APPLICATION FOR PRIVATE SEWAGE DISPOSAL PERMIT

JOB ADDRESS 22815 Timber Cove Rd
 NEAREST CROSS STREET Smith Ct
 ASSESSOR'S PARCEL NO. 109-430-029
 SUBDIVISION Timber Cove LOT 29 BLK
 CITY Timber Cove STATE CA ZIP
 SEWAGE DISPOSAL SYSTEM CONTRACTOR _____
 ADDRESS _____ TEL NO. _____
 GENERAL CONTRACTOR _____

REQUEST FOR SERVICE

SYSTEM SIZING AND PUMP CALCULATIONS
AT-GRADE DESIGN FOR A 2 BEDROOM HOUSE

SONOMA COUNTY PUBLIC HEALTH DEPARTMENT
Pre-Perc Field Notes

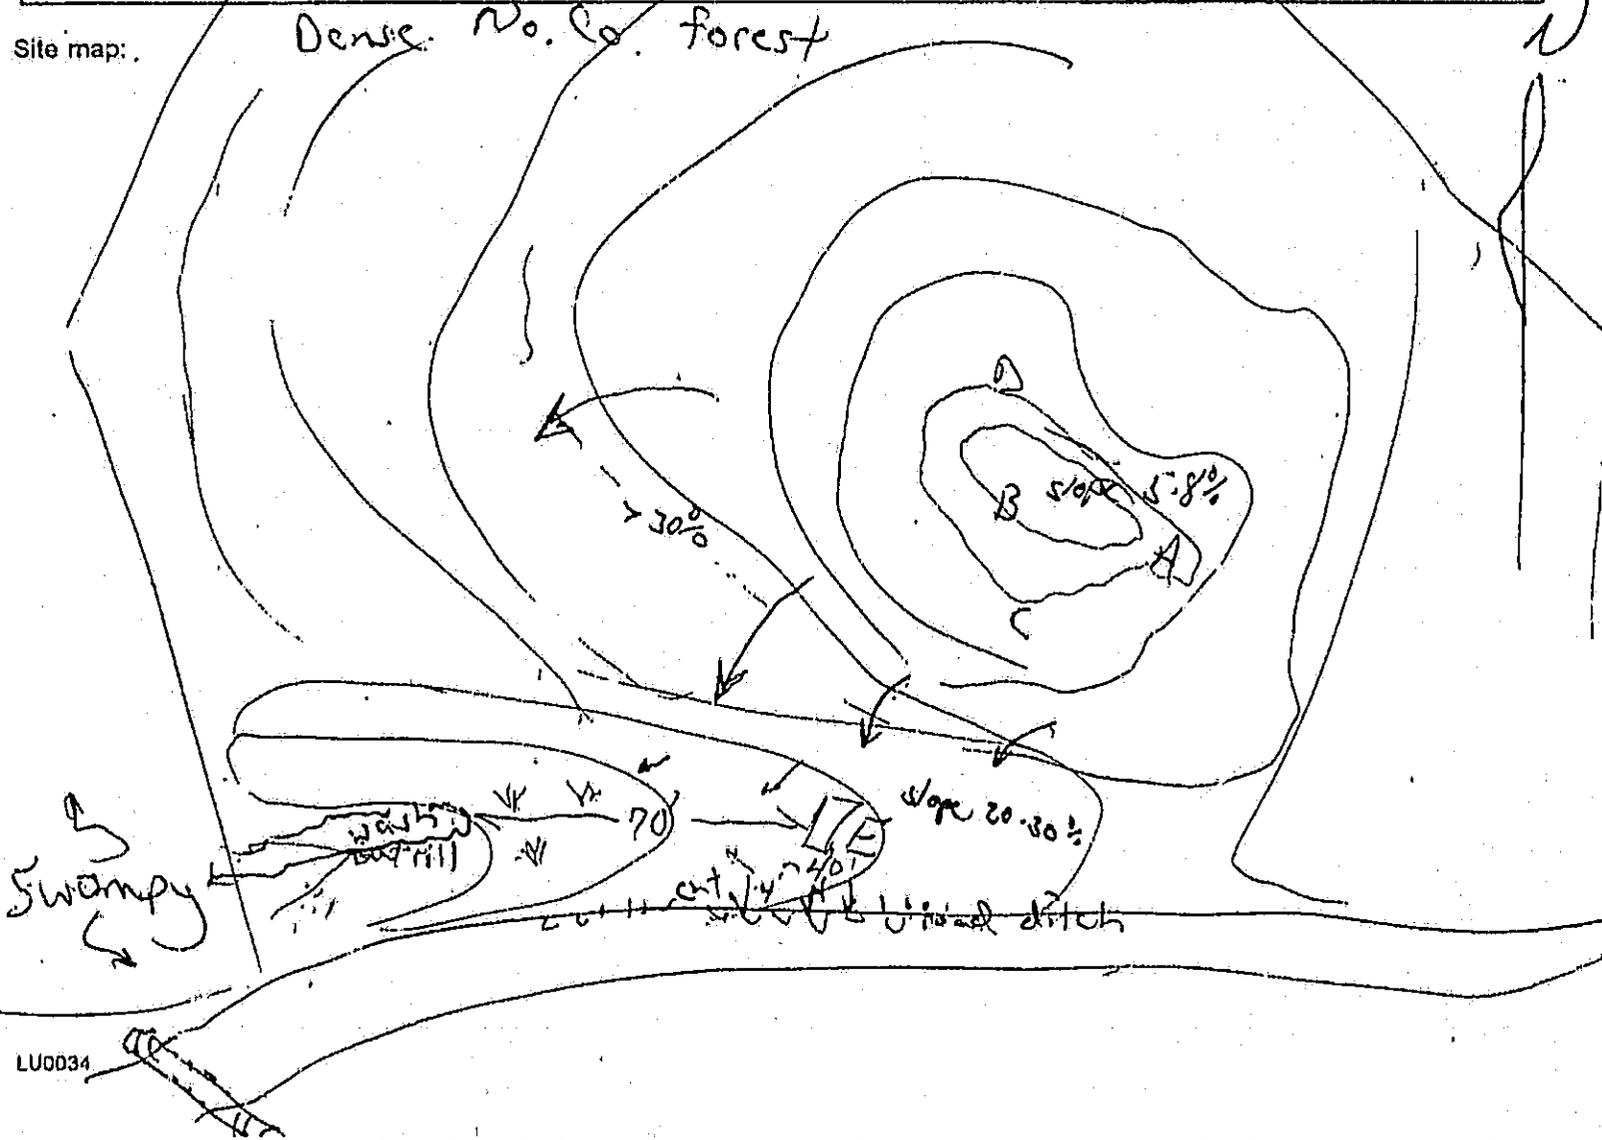
Other: Marginal - close to outbank & headwater of ephemeral stream, roadside ditch, grass

SONOMA COUNTY PUBLIC HEALTH DEPARTMENT
Pre-Perc Field Notes

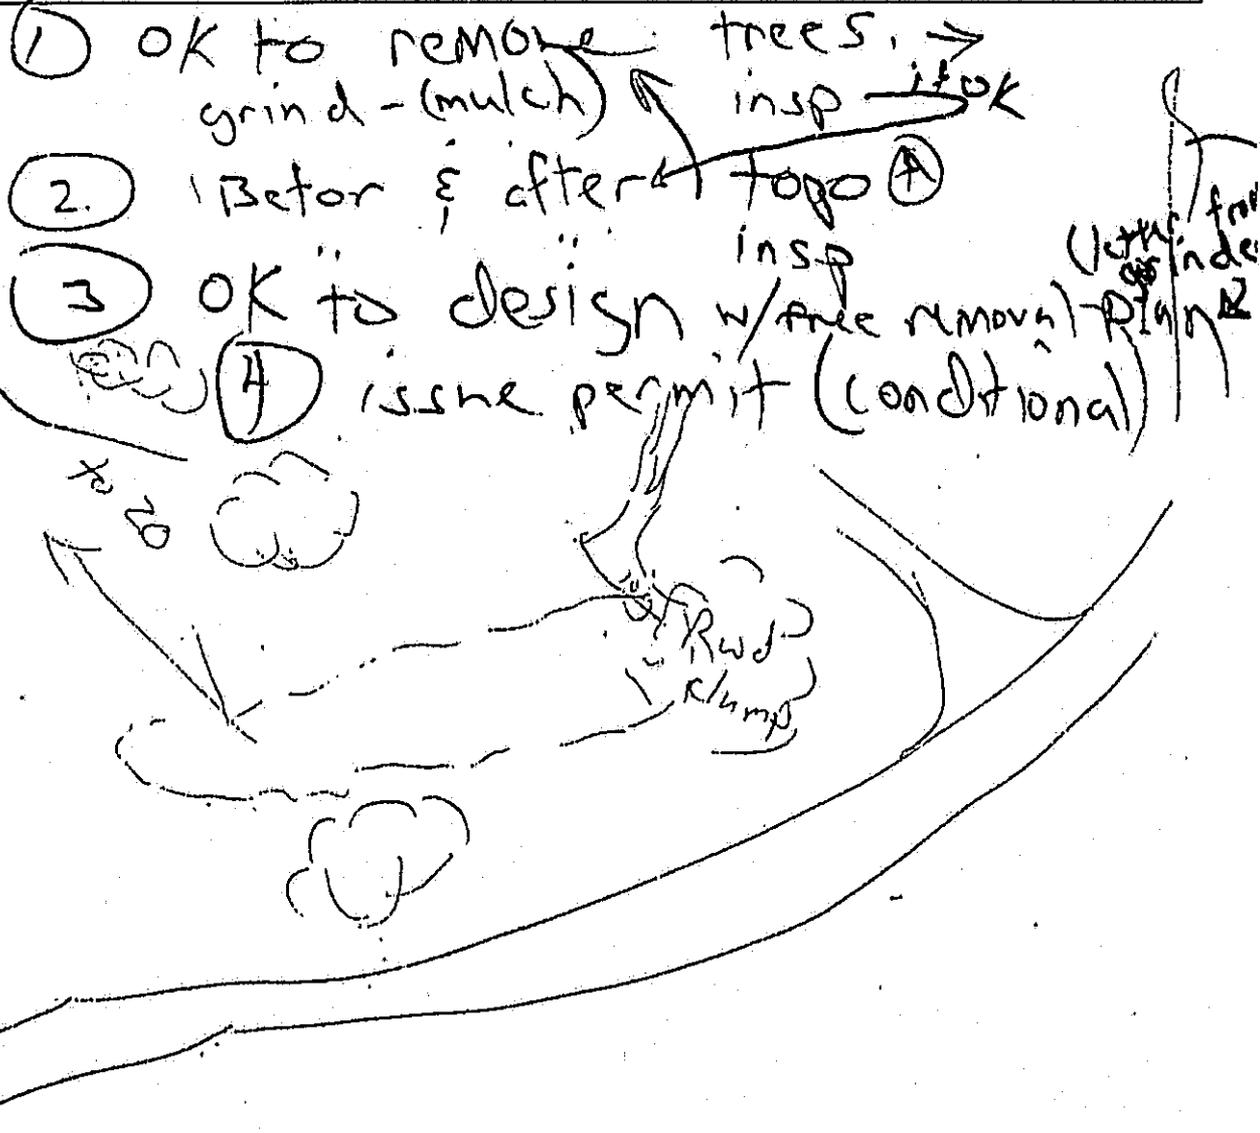
Hydrometer test: Yes <input type="checkbox"/> No <input type="checkbox"/> Depth(s) _____ Bulk density: Yes <input type="checkbox"/> No <input type="checkbox"/> Depth _____		
Wet-weather perc required: Yes <input type="checkbox"/> No <input type="checkbox"/> Wet-weather groundwater required: Yes <input type="checkbox"/> No <input type="checkbox"/>		
Subsoil perc depth(s) _____ Pump system: Yes <input type="checkbox"/> No <input type="checkbox"/> Perc depth(s) _____		
Type of system: <input checked="" type="checkbox"/> grade _____	Eng. design <input checked="" type="checkbox"/>	Topographic map req. <input checked="" type="checkbox"/> Geology report req. <input type="checkbox"/>
Comments:		
Do it dry

Counter
Site map:
consultation
w/ Ted, Rob, [Signature]
12-8-94
Stadua
